Remarks

Date: August 27, 2004

Amendments to the Drawings:

FIG 1

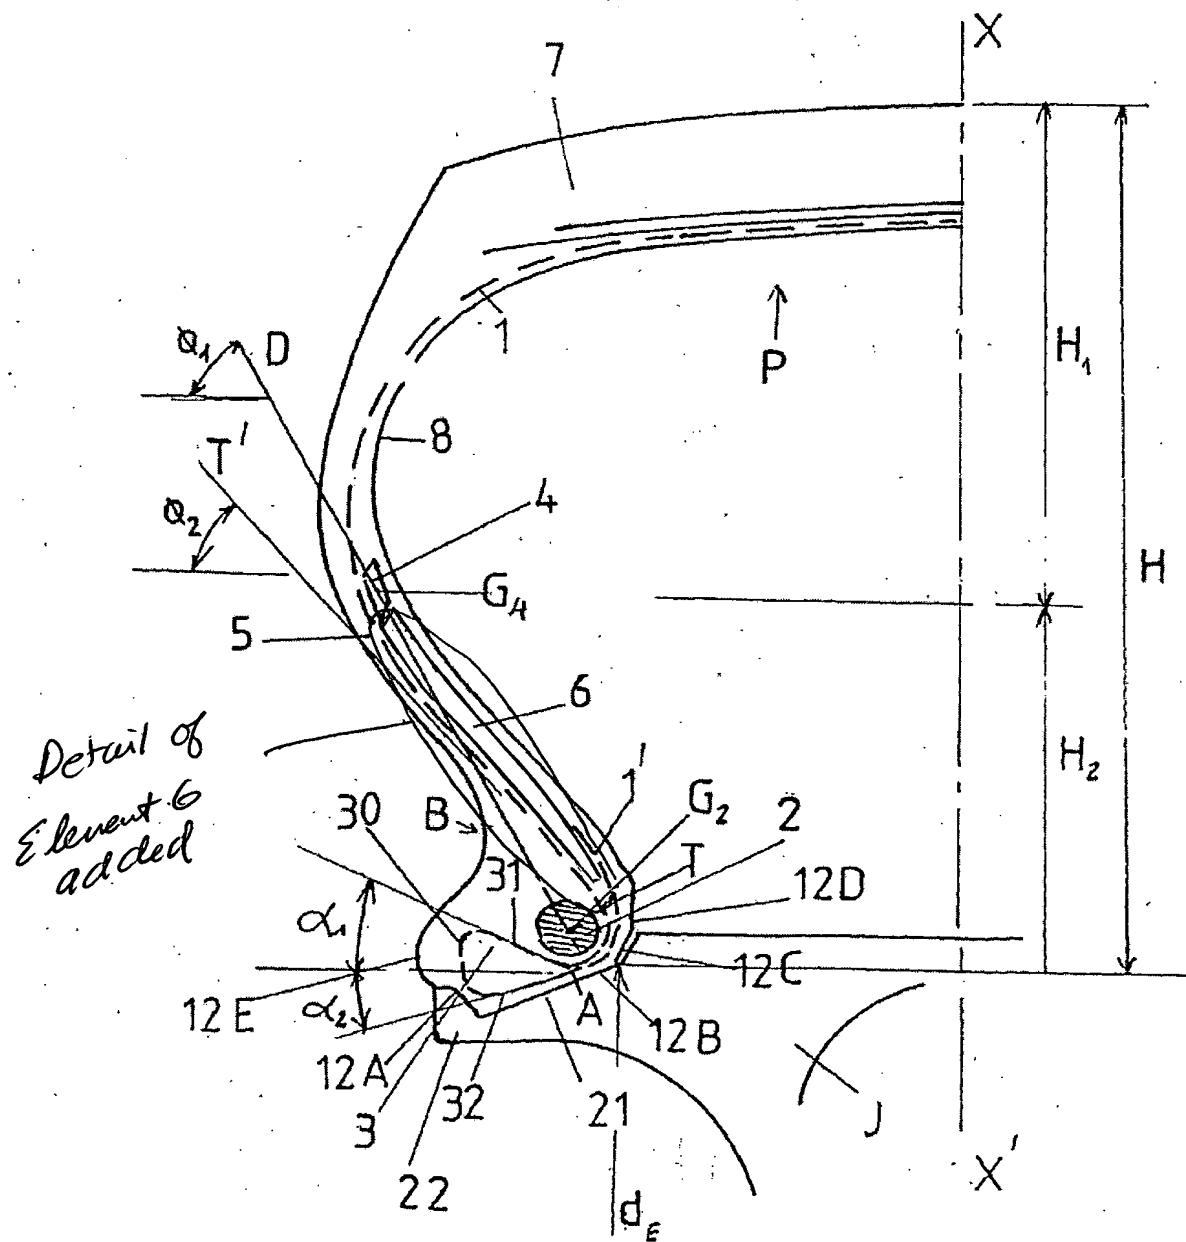
1. **Drawing Objections:** Figures 1 and 2 have been corrected to include a detail of the lower sidewall profiled rubber mix element 6. Figure 2 has been further corrected to include a detail of the crescent-shaped profiled rubber element 80. All corrections were made in conformance with the specification and claims as filed. No new matter was added.

The attached sheets of drawings include changes to Figures 1 and 2. The first two sheets replace the original Sheet 1/4 including Fig. 1. In Fig. 1, a detail showing an exemplary embodiment of the profile of element 6 has been added. The second two sheets replace the original Sheet 2/4 including Fig. 2. In Fig. 2, a detail showing an exemplary embodiment of the profiles of element 6 and element 80 have been added.
